NOVEMBER 2022

Verification Report

of the
Mt Fyans Wind Energy Facility
Pre- Construction Noise Assessment
August 2022

**Entura (a Hydro Tasmania
company)**

Figure 2: Predicted noise contours of GE candidate turbines (from Figure 2 MDA, August 2022)

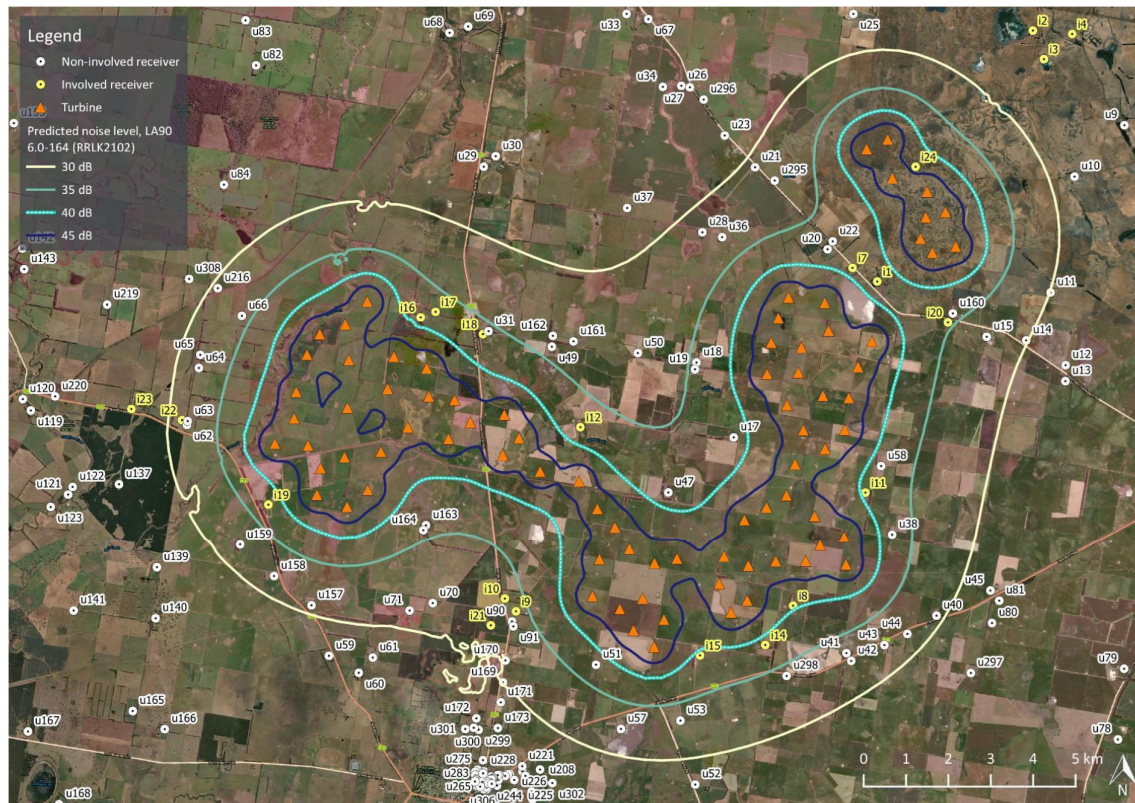
The WEF covers a large area with a number of non-stakeholder properties falling within the predicted 35 dB LA90 to 40 dB LA90 noise contours (e.g. refer Figure 2). The nearest turbine to a non-stakeholder NSL is assessed to be over 1.0 km (i.e. nearest being u38 at 1.14km).
